RFI / DA MODIFICATION ISSUE

20 OCTOBER 2023 - DA MOD ISSUE A-AX

CELADON APARTMENTS

22 SWANN ROAD TARINGA & 15 CUNNINGHAM STREET TARINGA

EXISTING SITE PLAN
Scale 1:300 at A1

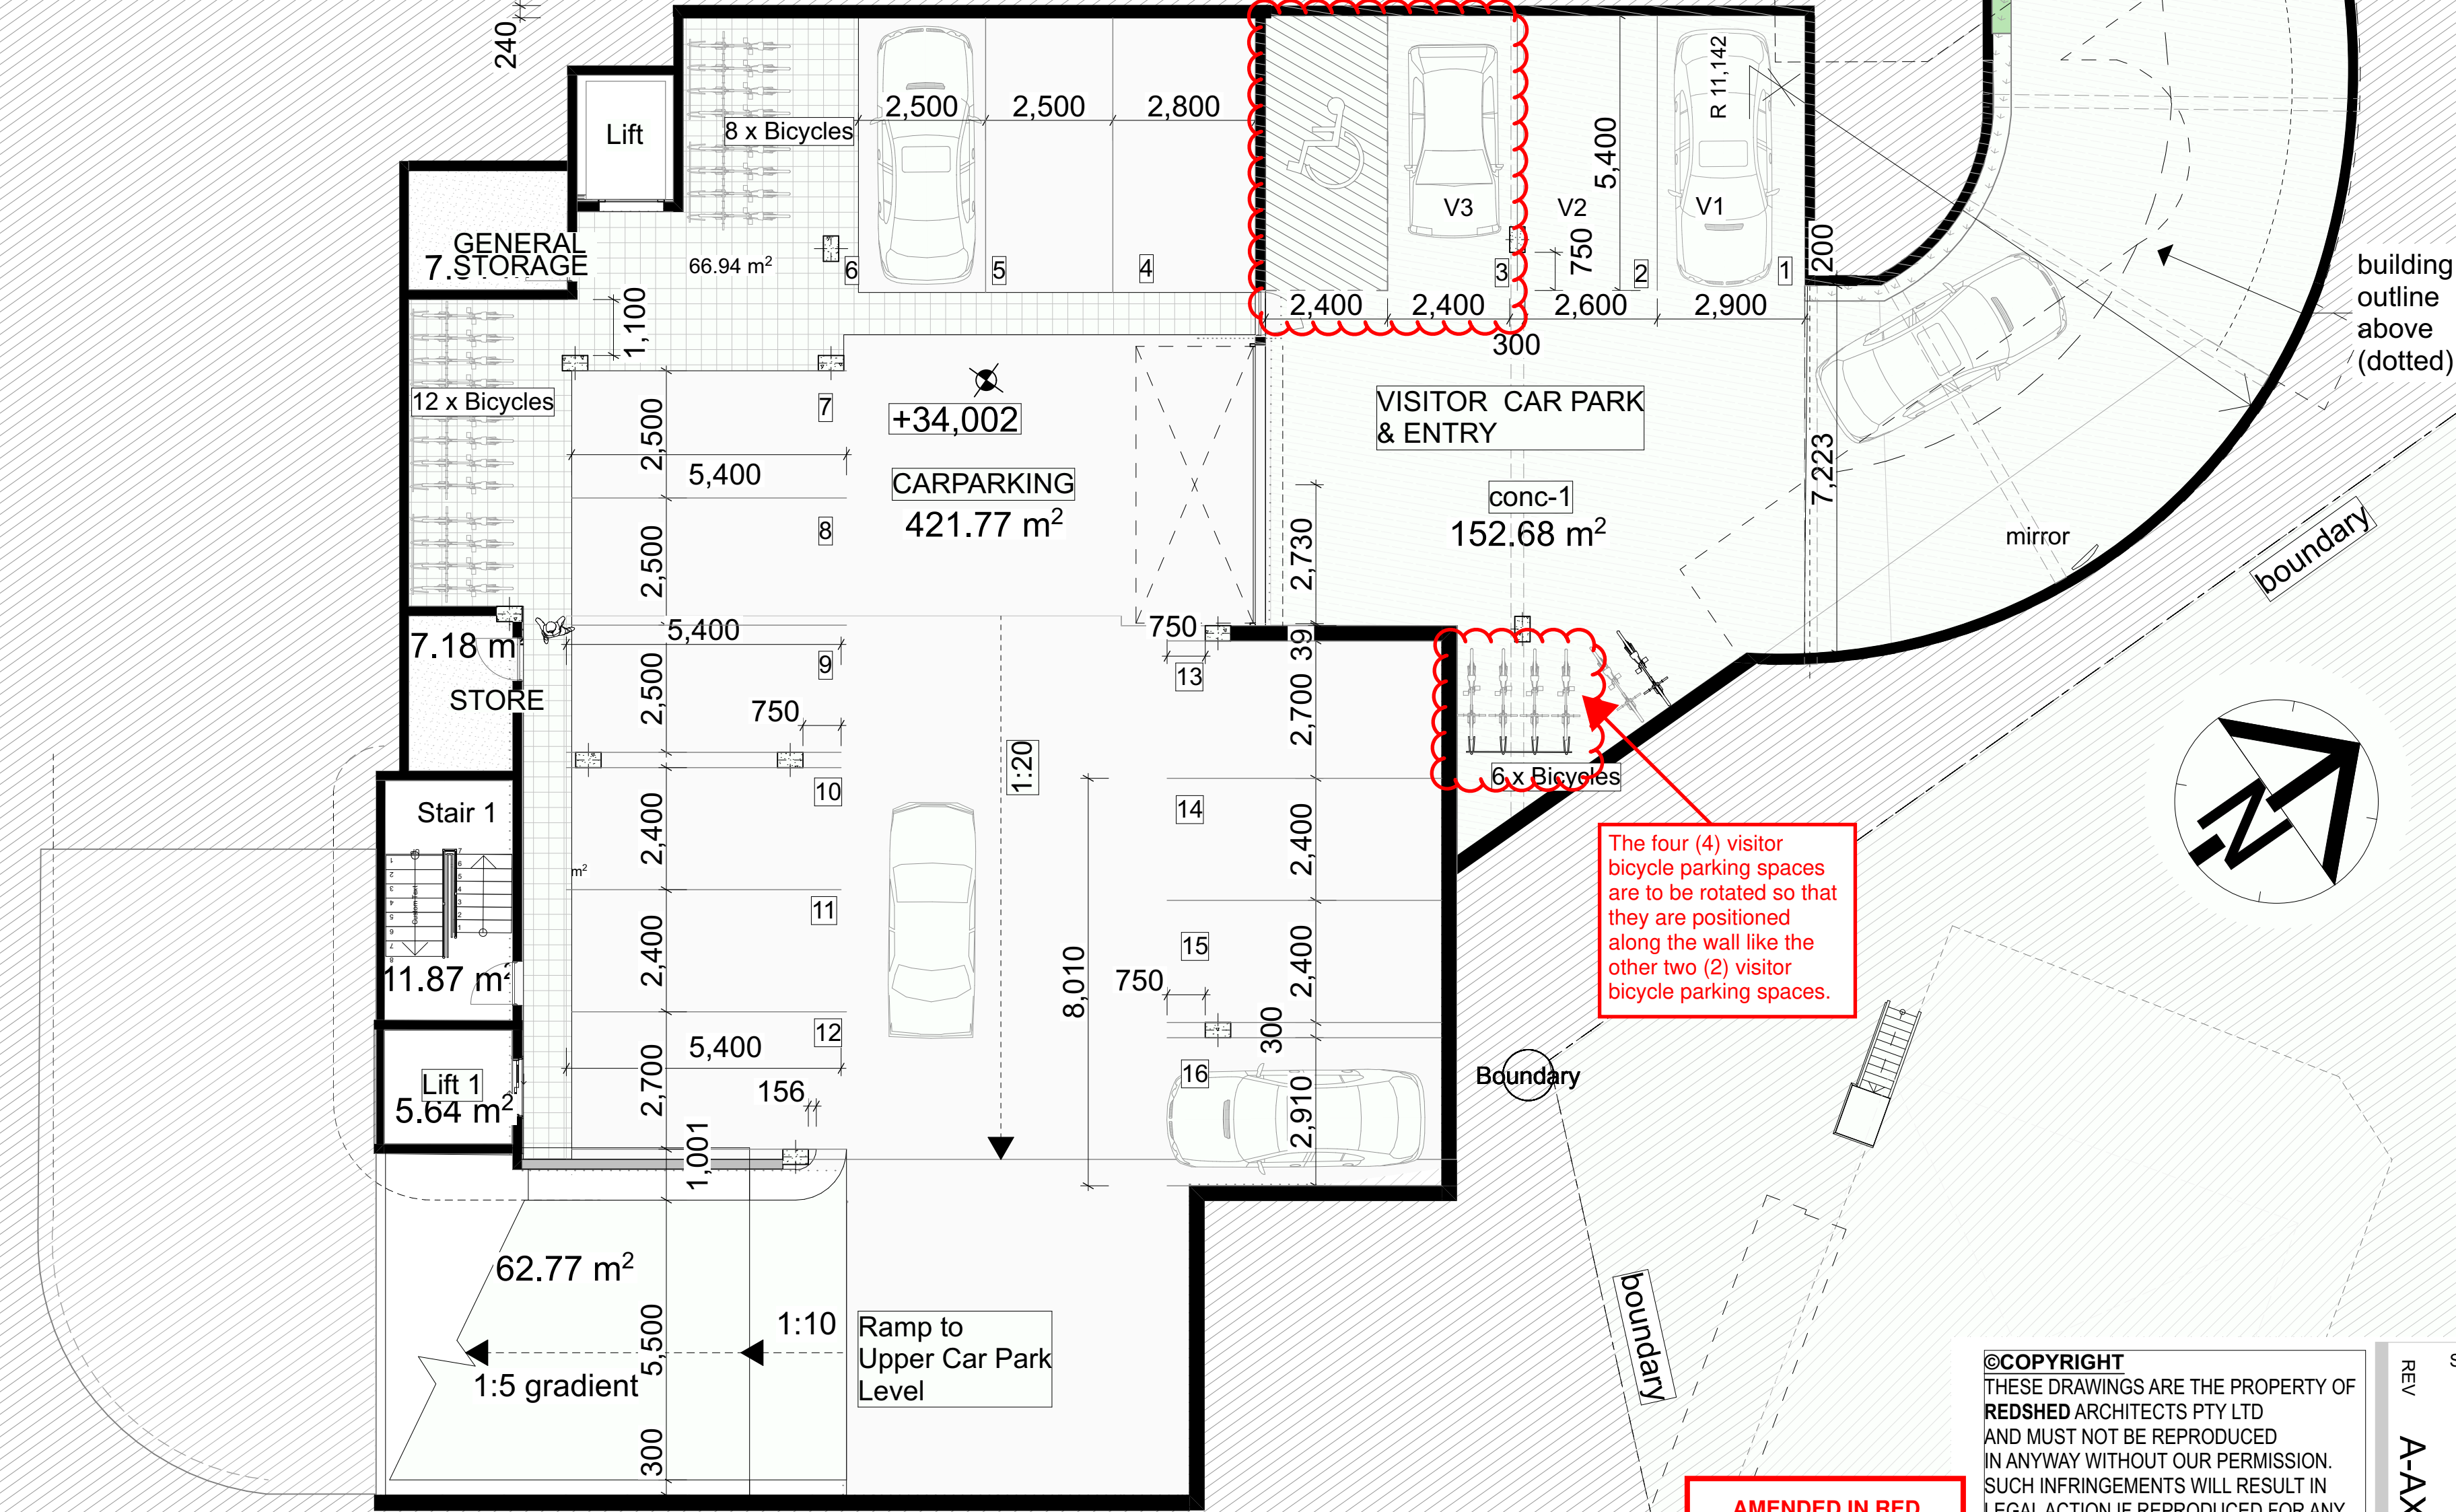
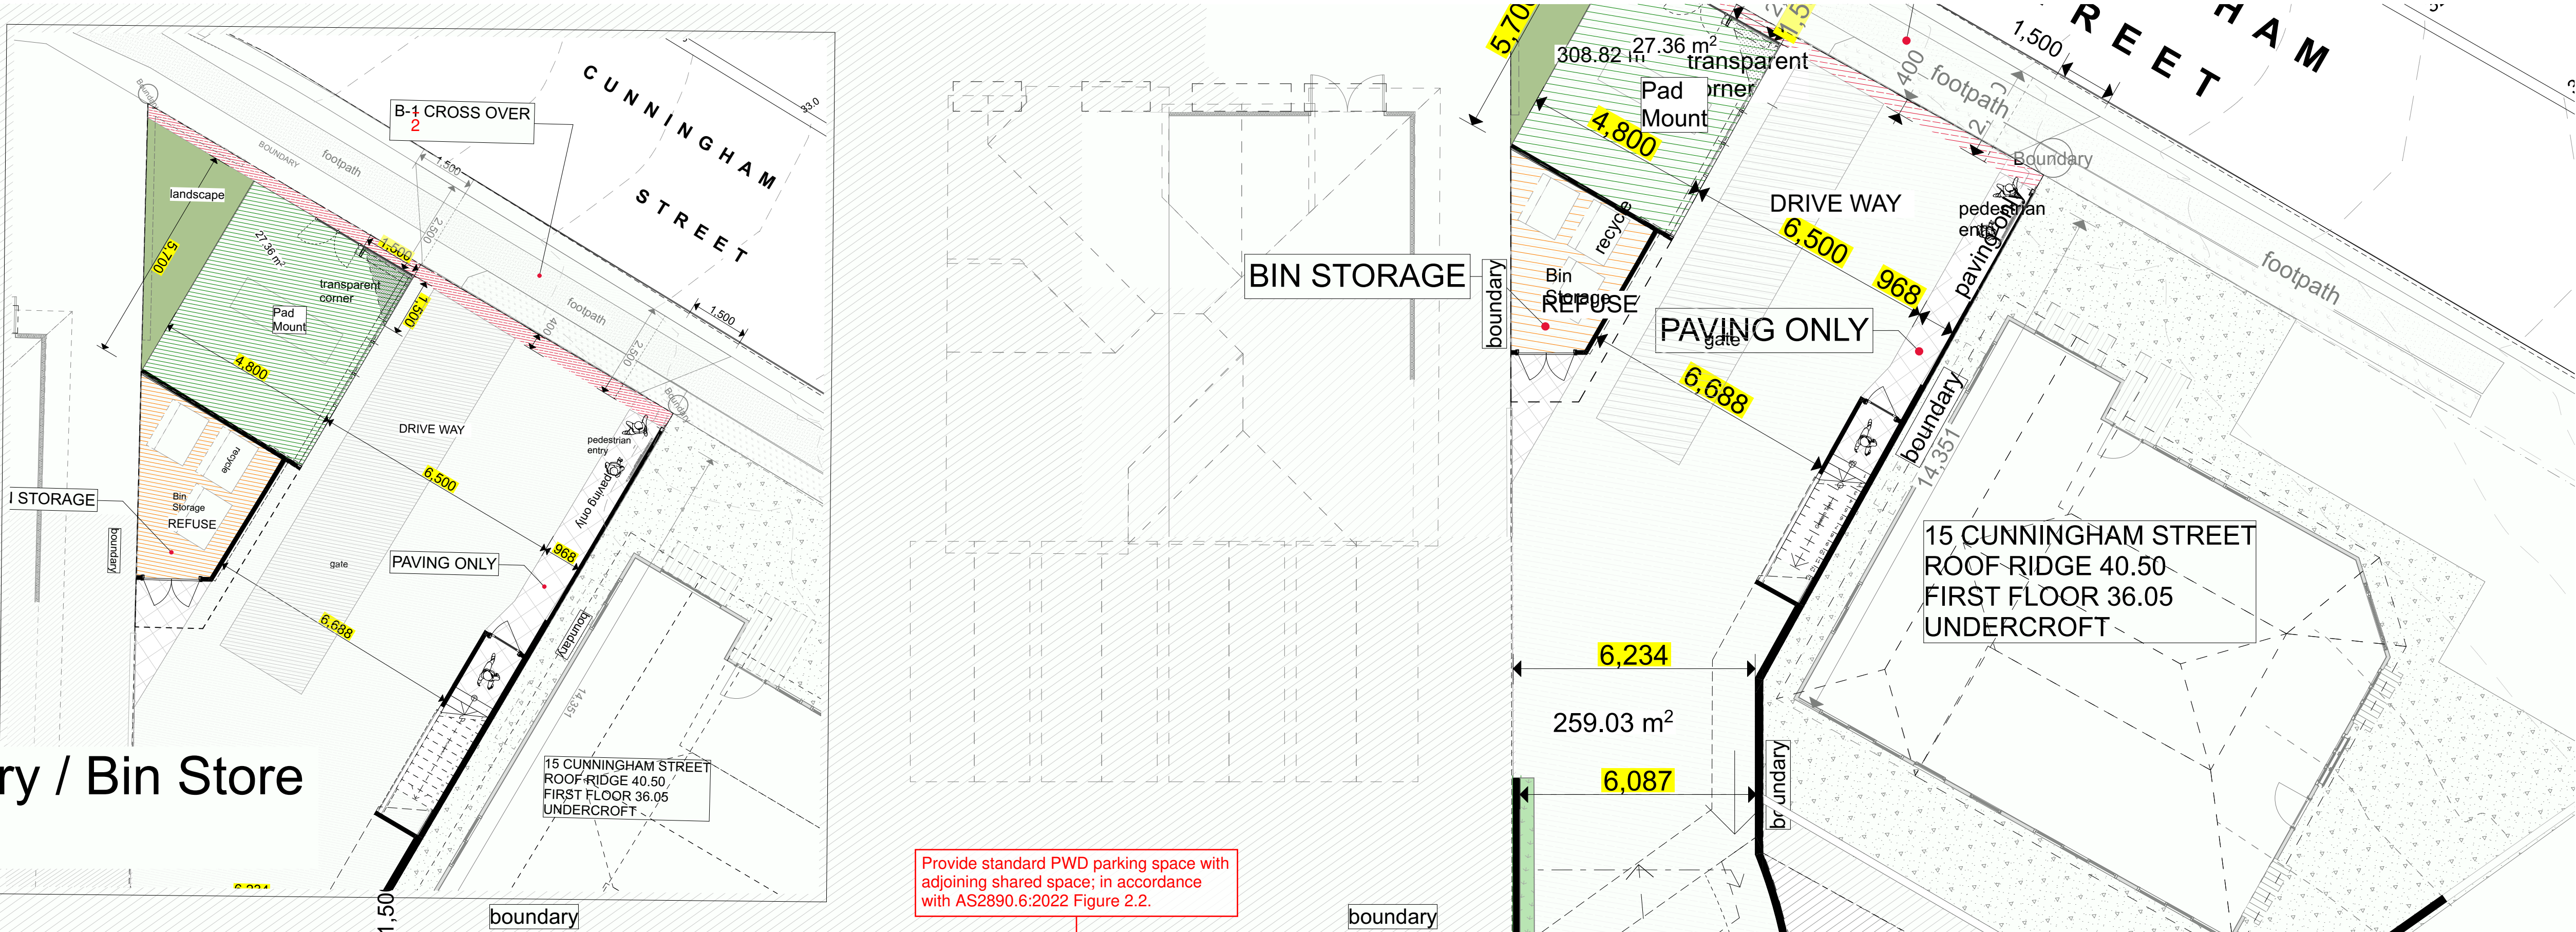
Dedicate as road reserve the land required to provide pedestrian amenity, including the following:
a) A widening along the full length of the Swann Road frontage of the site to establish a minimum verge width of 3.750m measured from the nominal face of kerb.
Note that existing verge varies from 3.1 to 4.2m, i.e. requiring a dedication between 0-0.65m.
b) A widening along the full length of the Cunningham Street frontage of the site to establish a minimum verge width of 2.50m measured from the nominal face of kerb.
Note that existing verge varies from 2.0 to 2.25m, i.e. requiring a dedication between 0.25-0.50m.

AMENDED IN RED
18/12/2023
